ADDENDUM NO. 1

**Administration Building Renovation Re-bid
Compton Community College District**

tBP Project. No. 20987.00

tBP/ARCHITECTURE

drawing title:
ENLARGED TOILET PLAN

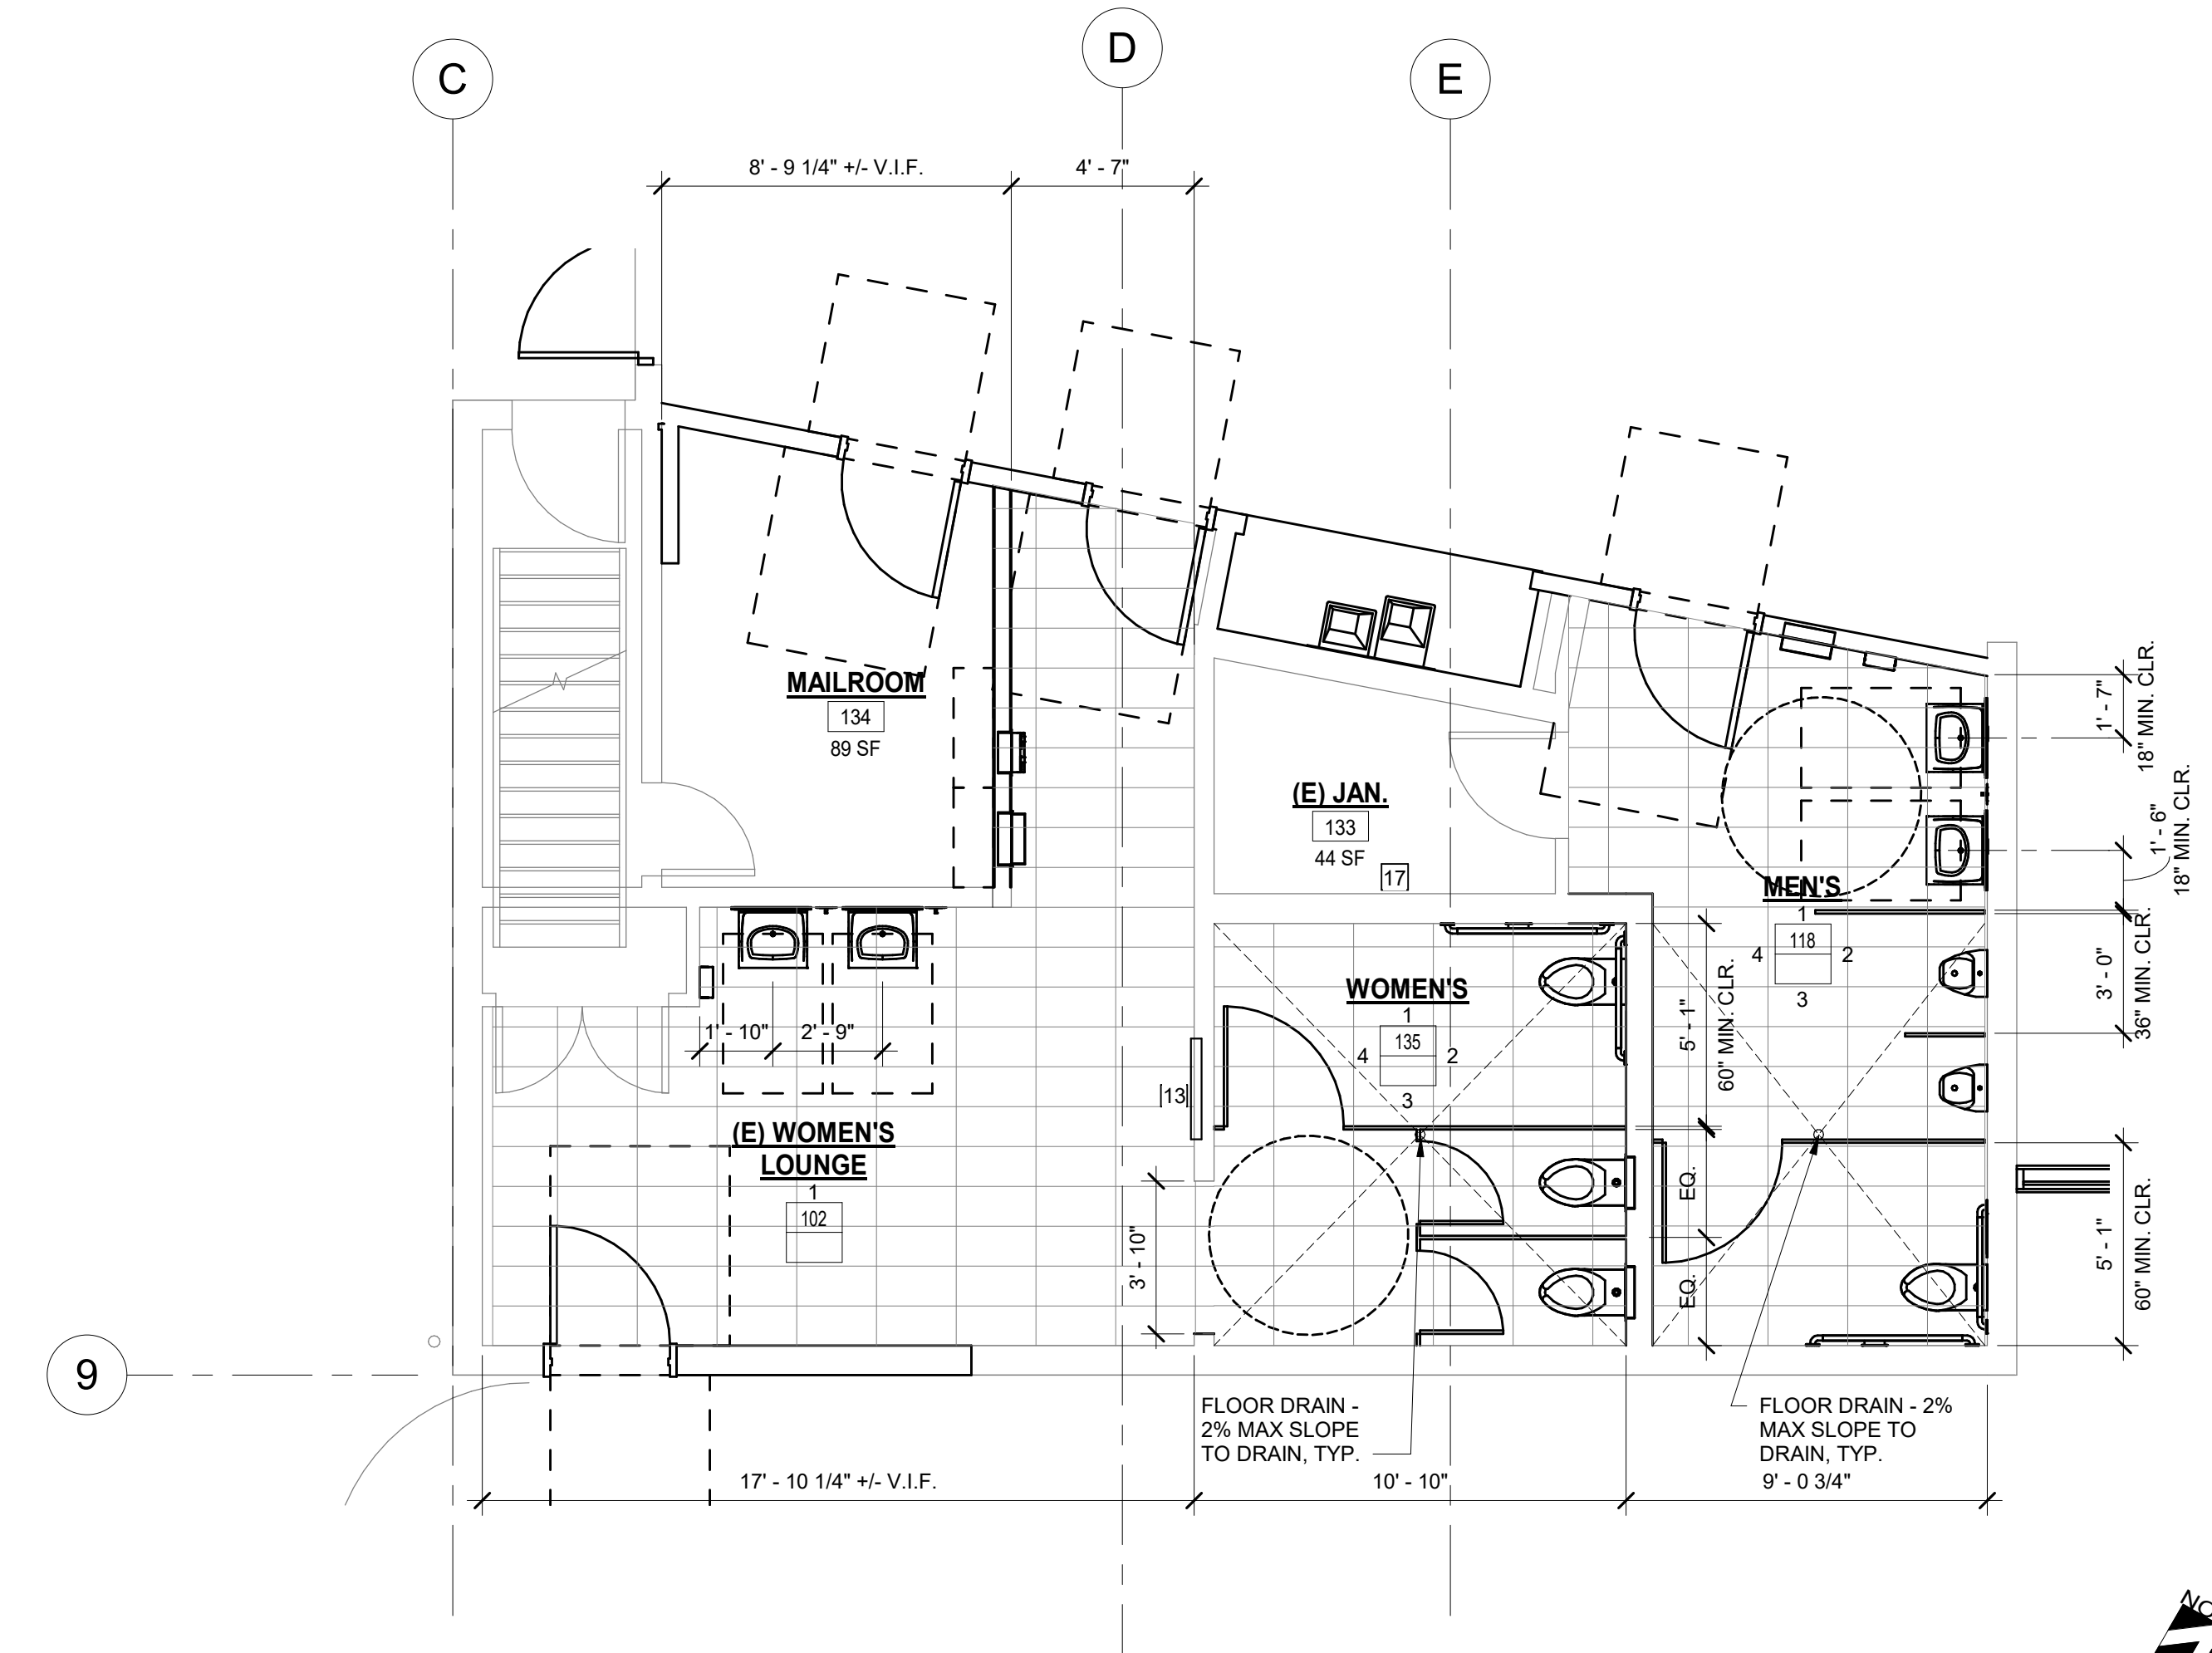
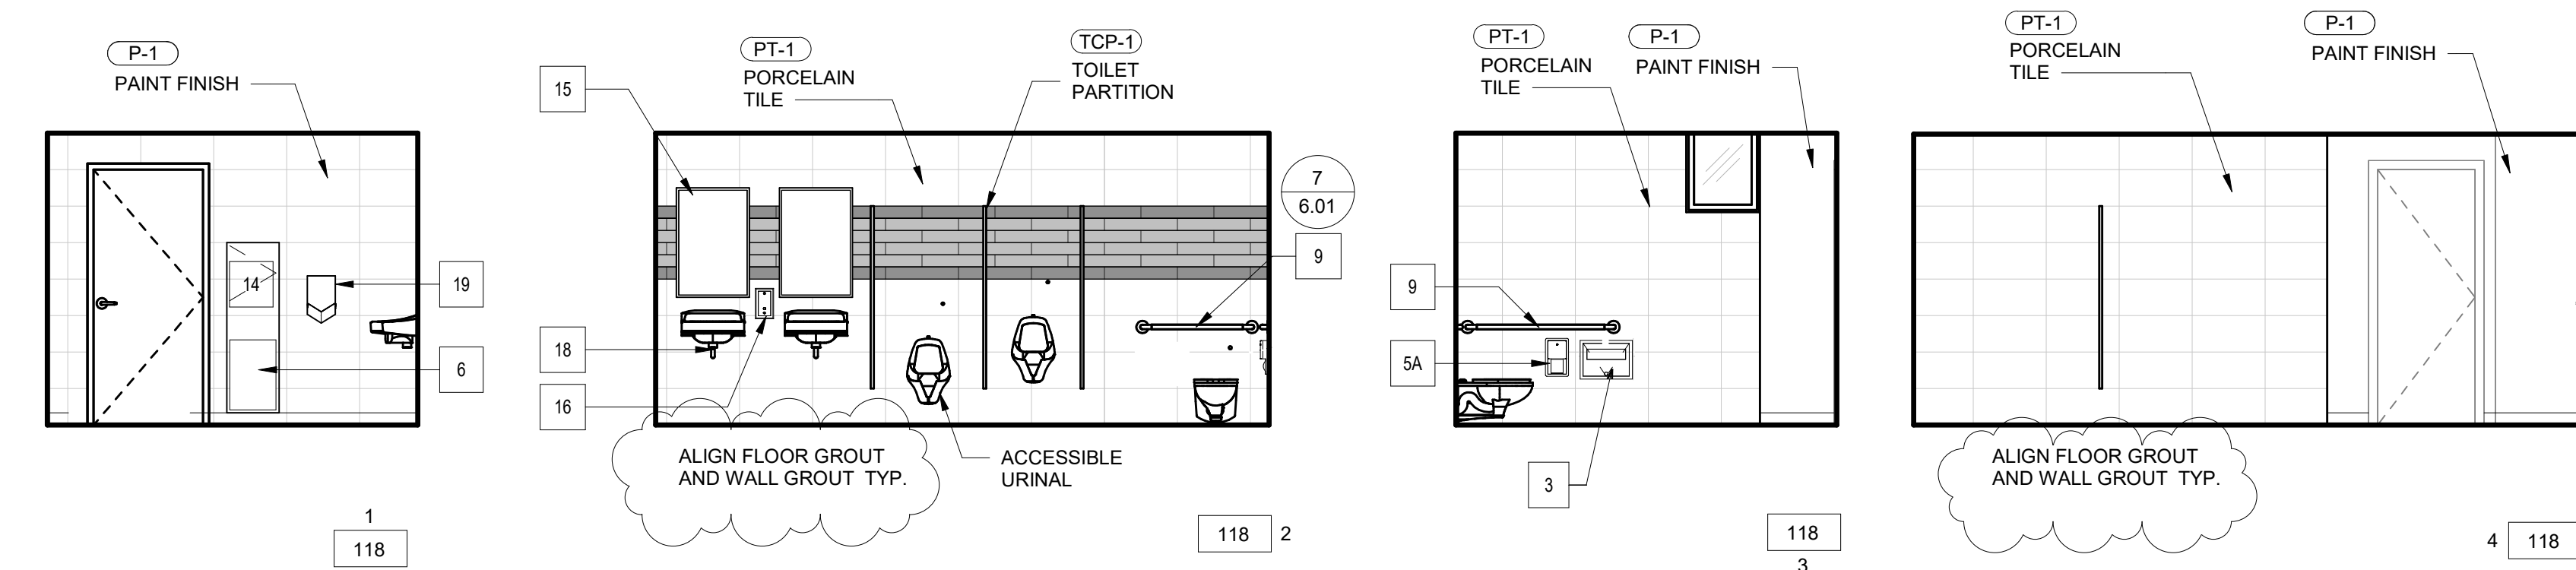
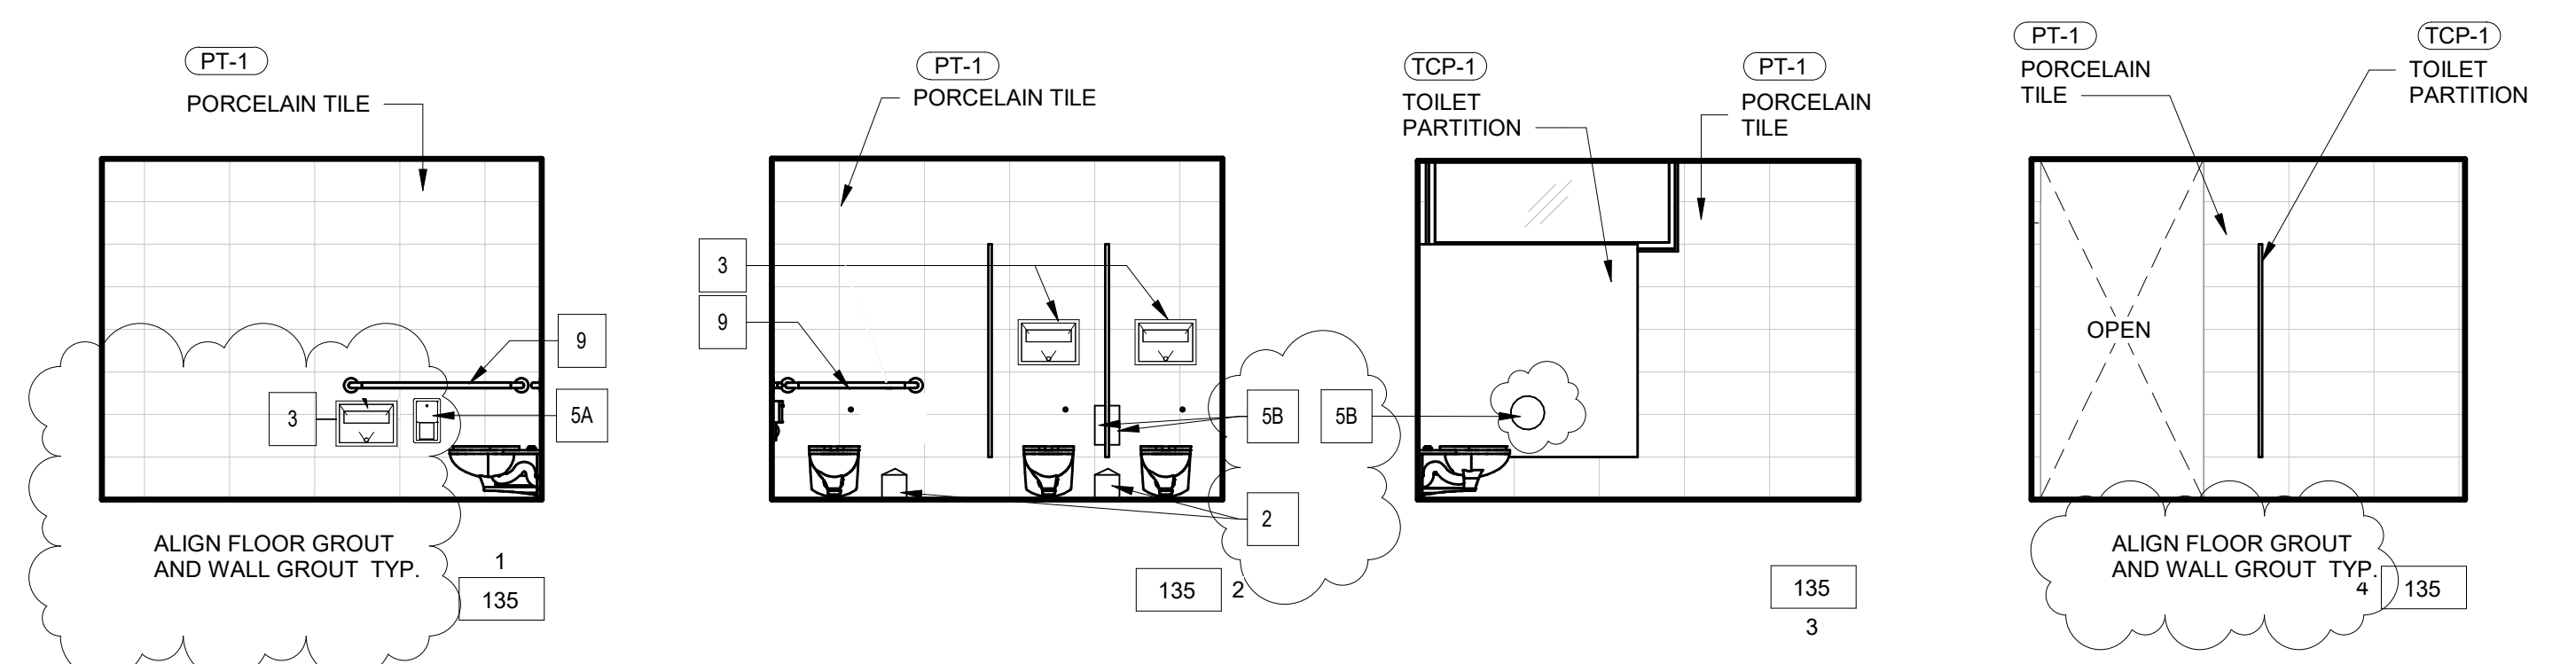
9. Revised SHEET A7-1 ENLARGED TOILET PLAN

- a. Toilet Accessories Keynotes revised to ADD OFCI at non-ADA stalls.
- b. Added note for align wall grout with floor grout.
- c. Corrected some graphics at Women's Lounge.
- d. Shows DF relocation.
See attached revised Full size sheet identifying revisions included as part of this addendum.
